Submission of Further Information (FI)

**Proposed Temporary Public Vehicle Park (Excluding Container Vehicle) and
Associated Filling of Land for a Period of 3 Years in "Village Type Development"
and "Agriculture" Zones, Various Lots in D.D. 9, Yuen Leng, Tai Po, New Territories**
(Application No.: A/NE-KLH/658)

Further Information for Planning Application No. A/NE-KLH/658**Response-to-Comments****Comments from the Water Supplies Department**

Comments from the Drainage Services Department

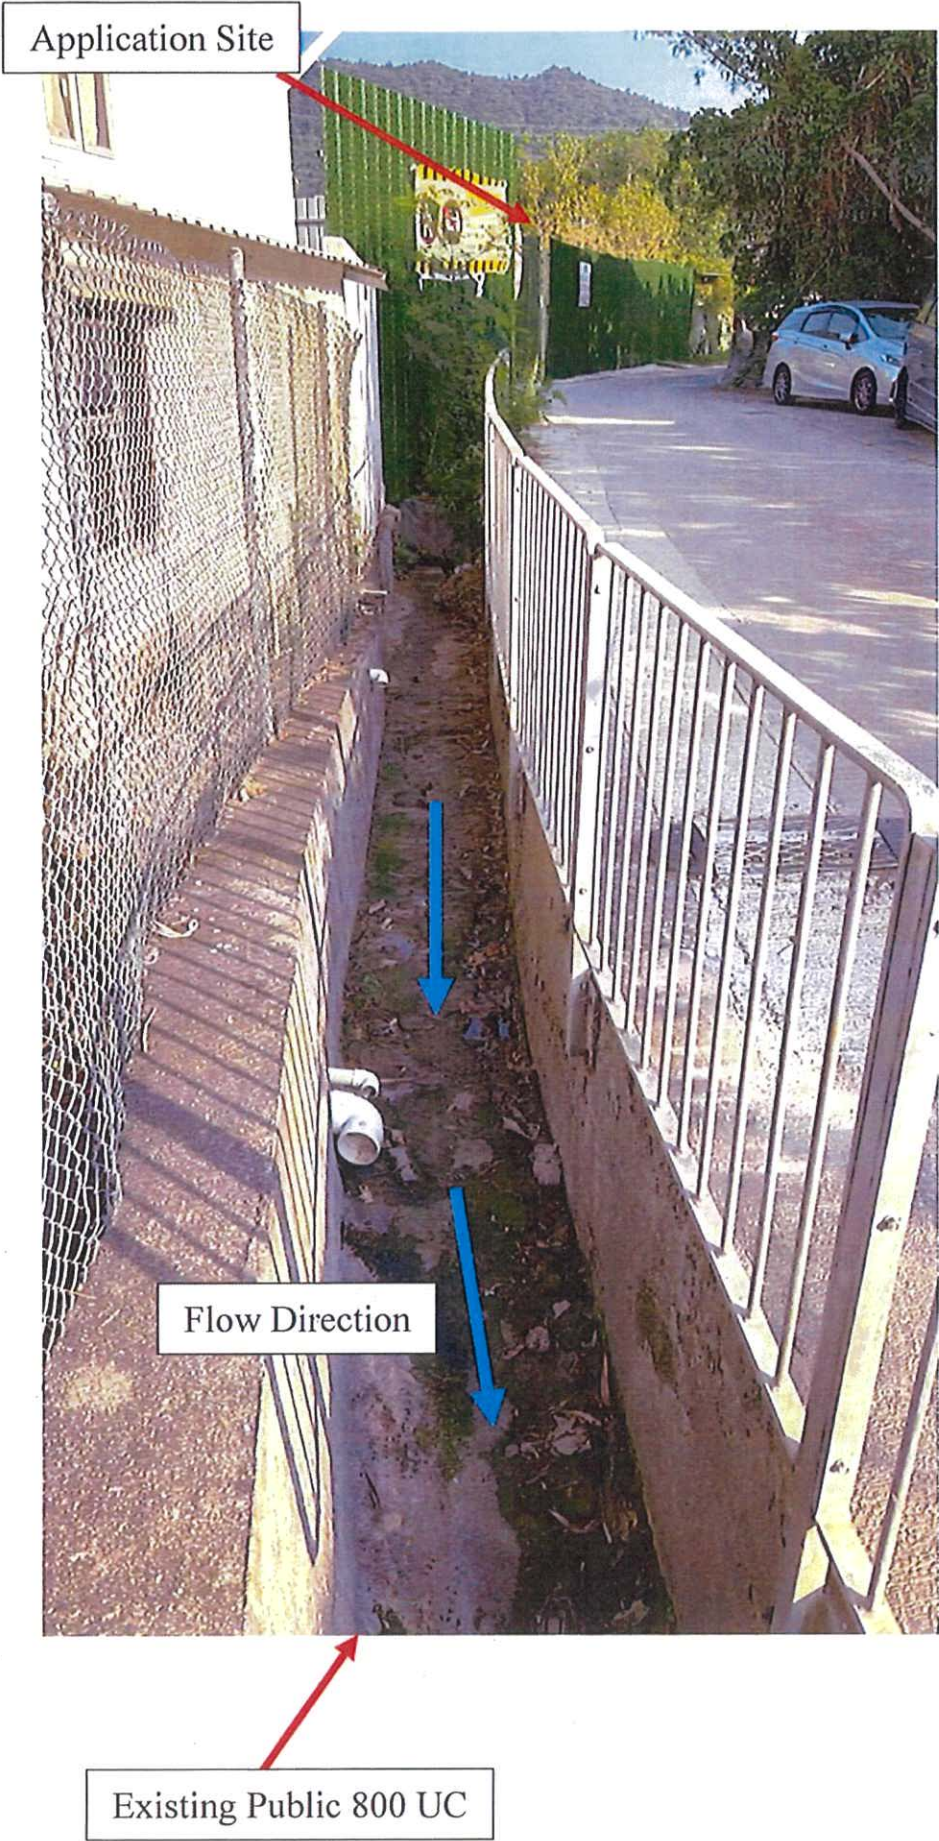
II.	Comments	Responses
1.	The drainage flow path from the drainage facilities within the Site to the public drainage system / streamcourse / sea / any recognized drainage facilities shown in LandsD map should be provided in associated with supporting site photos.	Please refer to the Viewpoint photos.

Plan 5.1a
(P 25046)

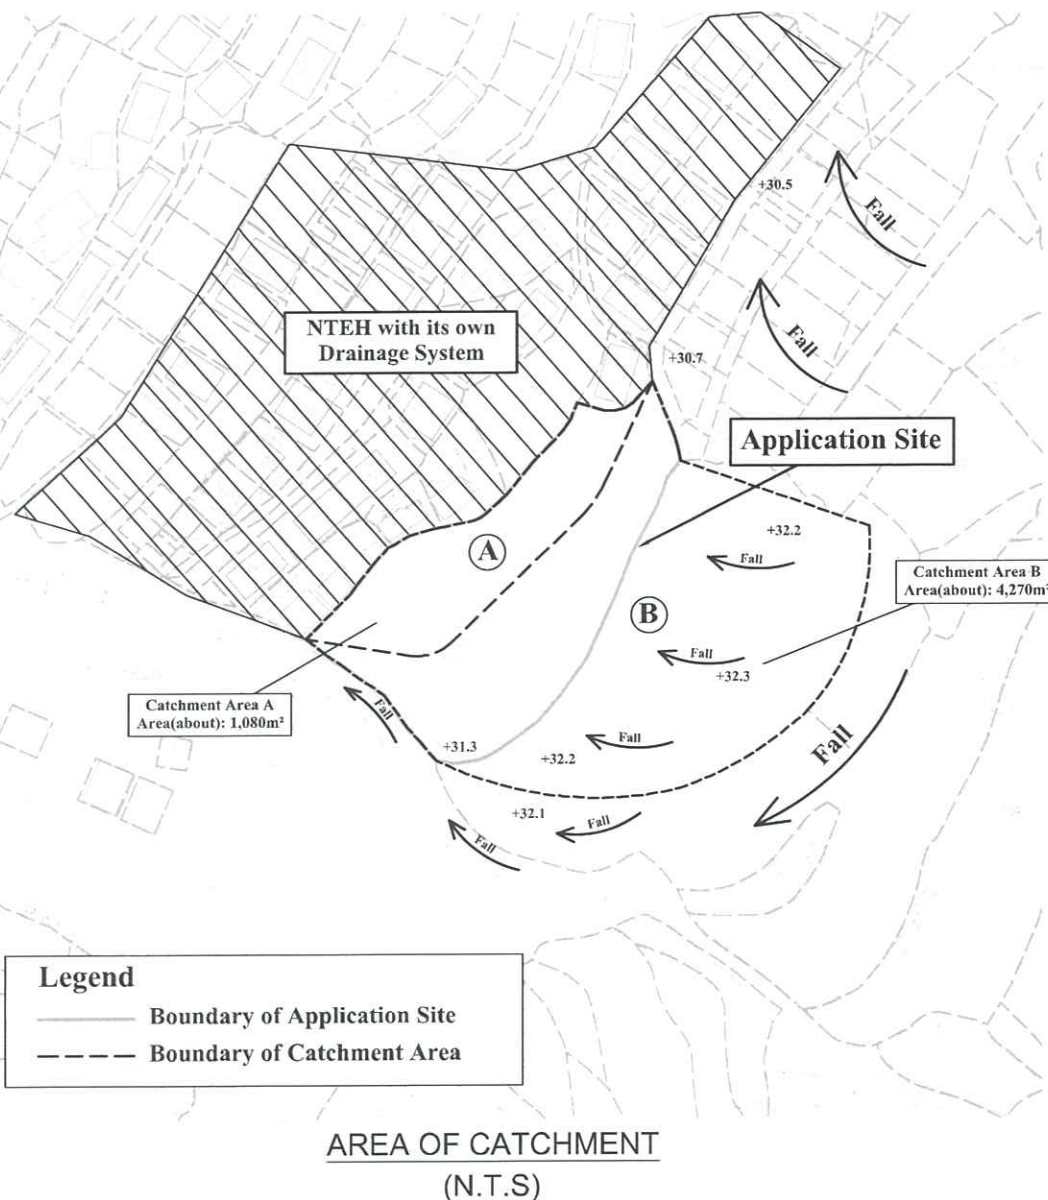
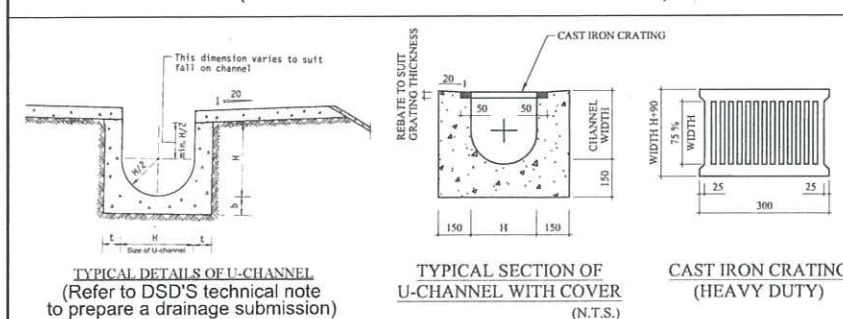
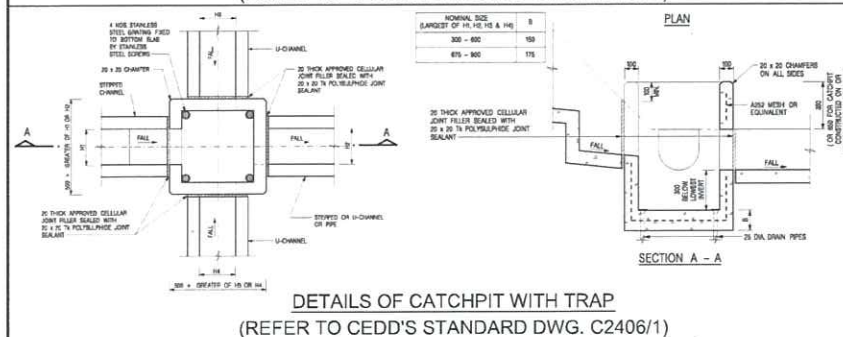
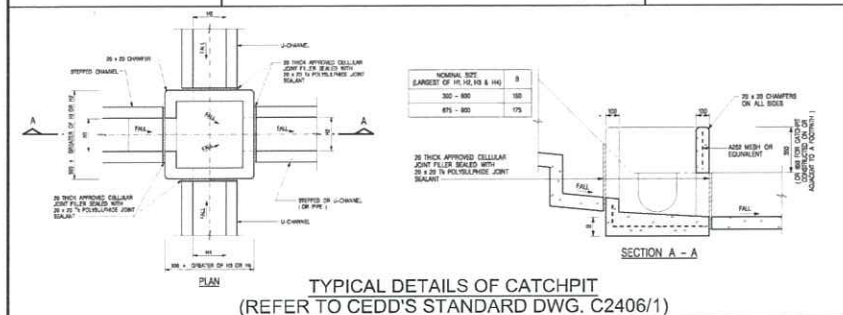
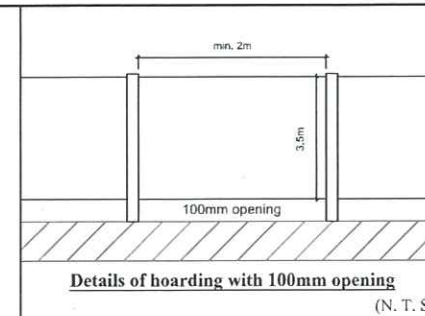
4.	Please specify the extent of the proposed hoarding and location of the hoarding opening on the plan.	Noted. The extent of the proposed hoarding and location of the hoarding opening is specified on Plan 5.1a. Please refer to the Legend on the Plan.

5.	The proposed drainage works, whether within or outside the application site, should be constructed and maintained by the applicant at his expense. Please specify the	Noted. Please refer to Plan 5.1a.

Plan 5.2
(P 25046)

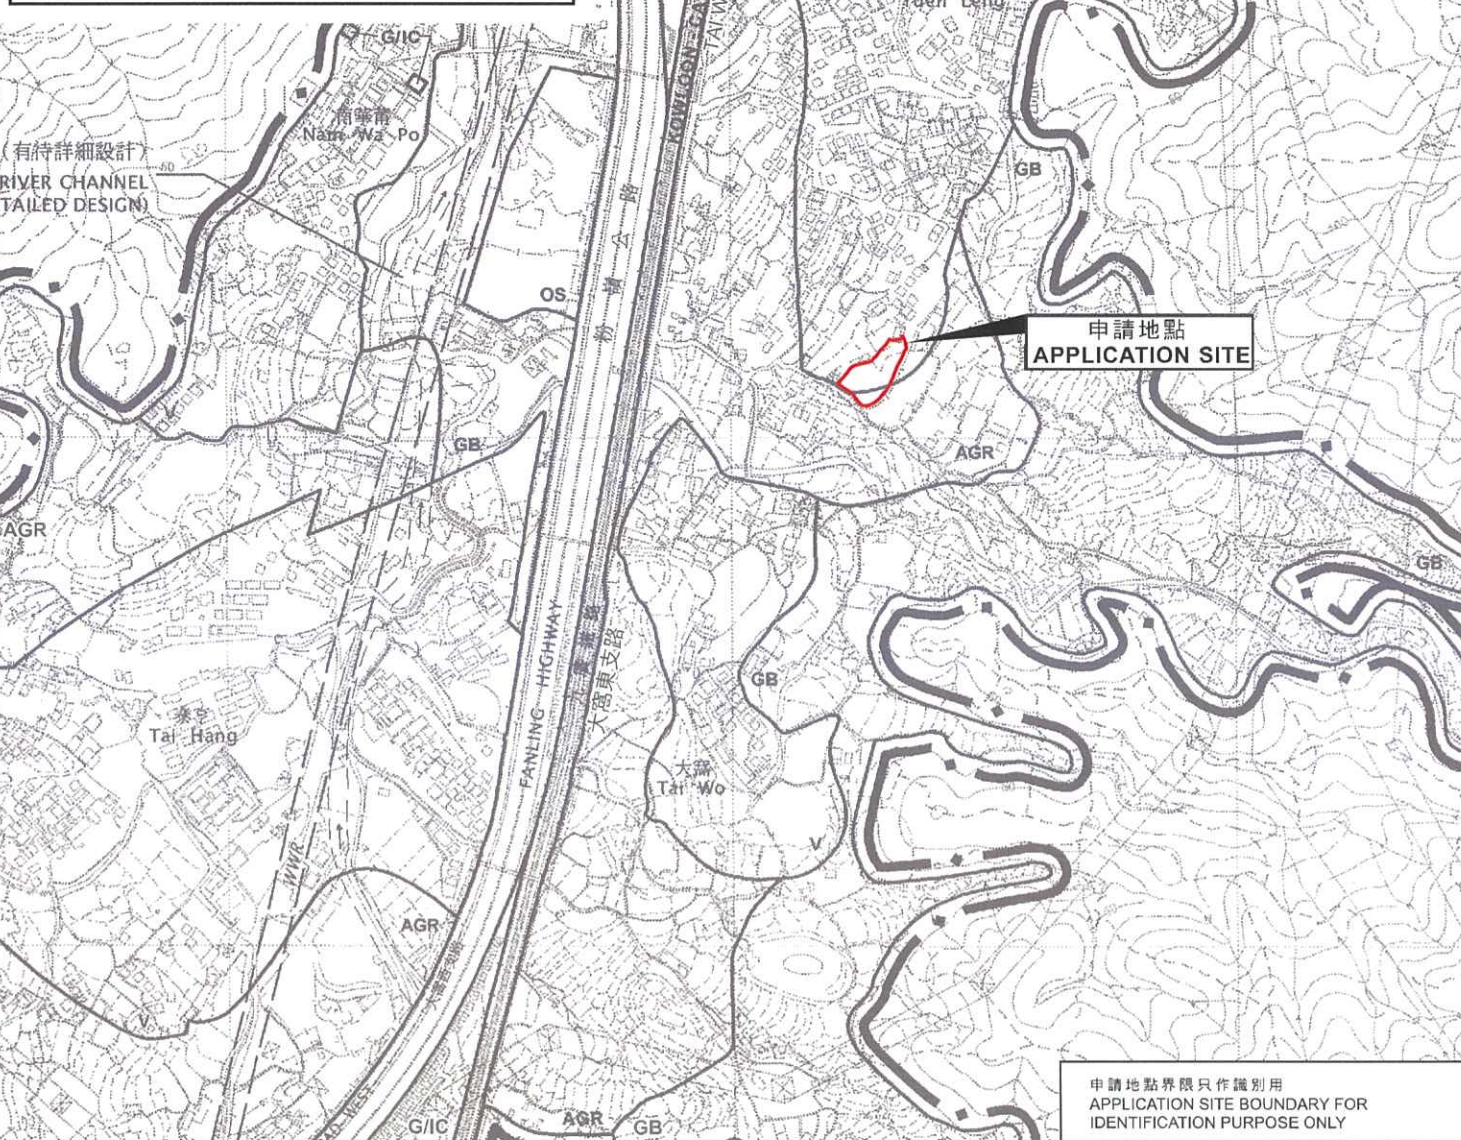
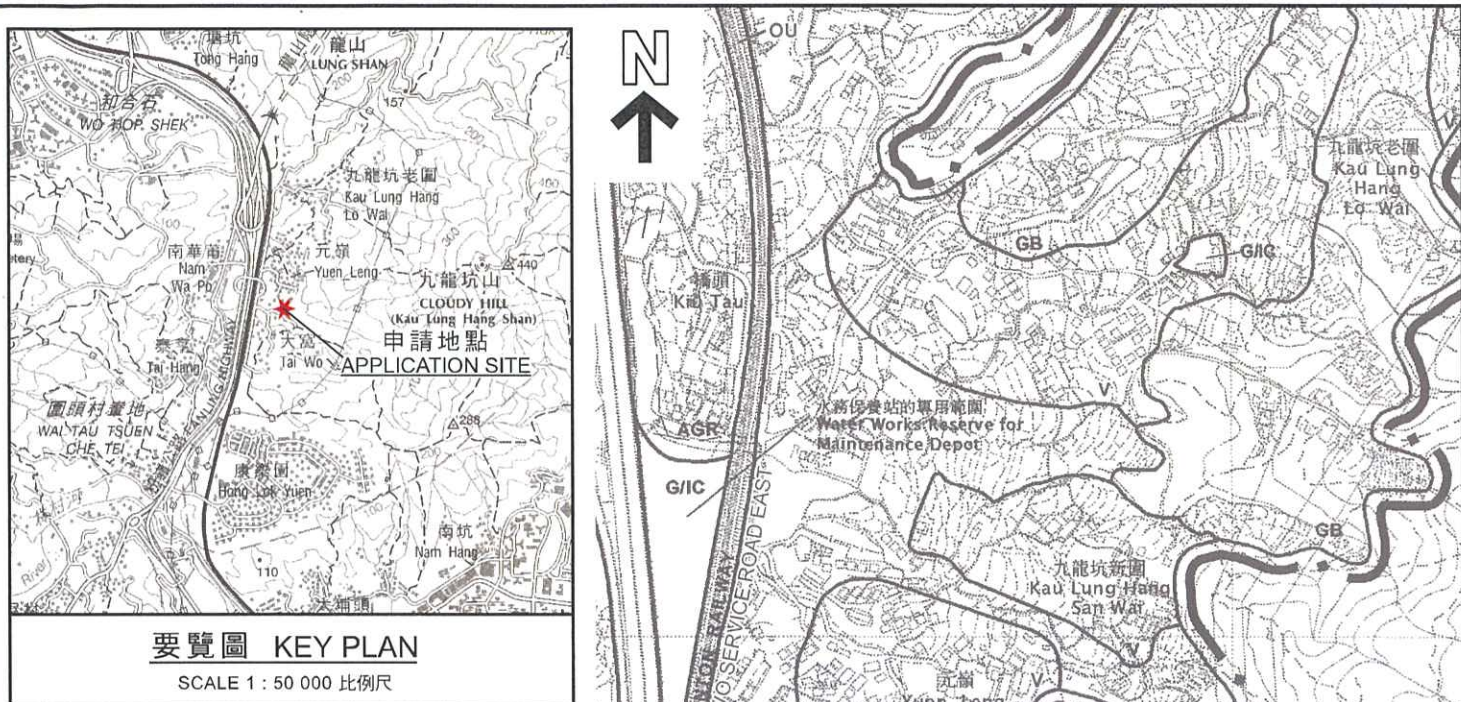
2.	Please provide topography of the adjacent areas.	Please refer to Plan 5.2 for the topography of the adjacent areas.
3.	Catchpit should be provided at intersections of u-channels.	Catchpit is provided at intersections of u-channels. Please refer to Plan 5.1a.
